## 2 Type of change

### 0909 Multiple IEC Appliance Outlets F

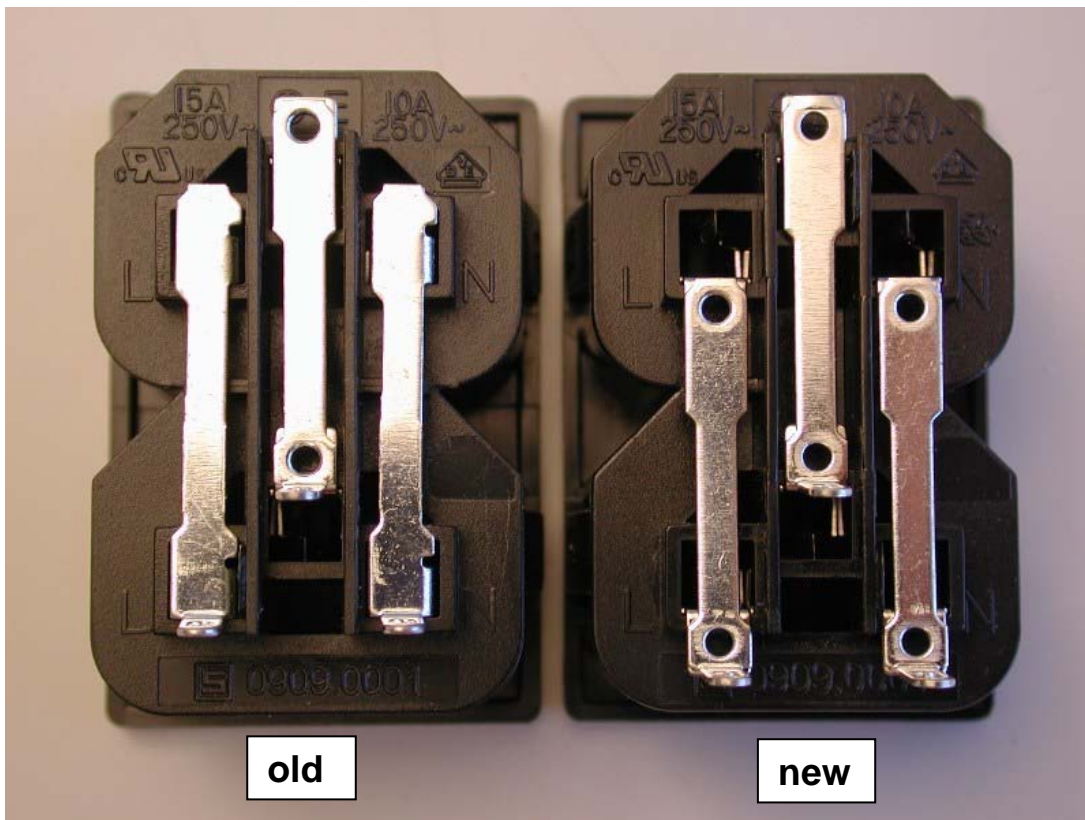
- L and N bars newly riveted to contacts, now are all 3 bars (L/N/E) riveted.
- Position of solder terminals of L&N are moved approx 5mm towards the border of the connector.

The old version had only the earth bar riveted to the outlet contacts - L/N bars and contacts were made of one piece. The new version has L/N/E riveted. (The holes are the riveting joints)

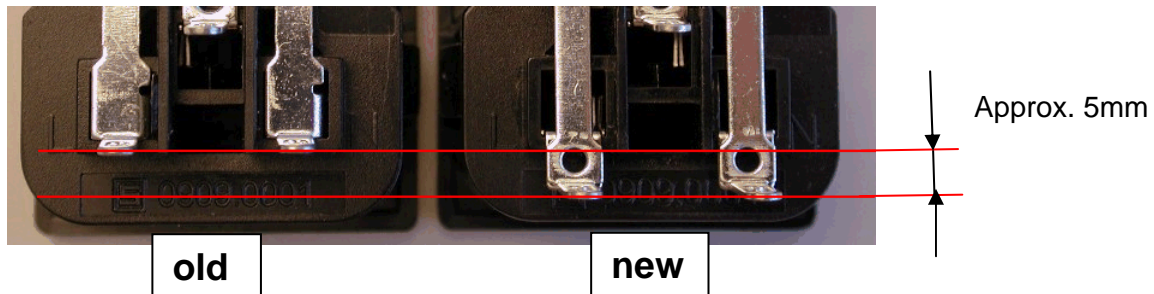
Position of solder terminals of L&N are moved approx 5mm towards the border of the connector.

Form: New internal joining technique, solder terminals of L&N are moved approx 5mm towards the border of the connector.  
 Fit: No influence  
 Function: No influence  
 Production Site: No influence
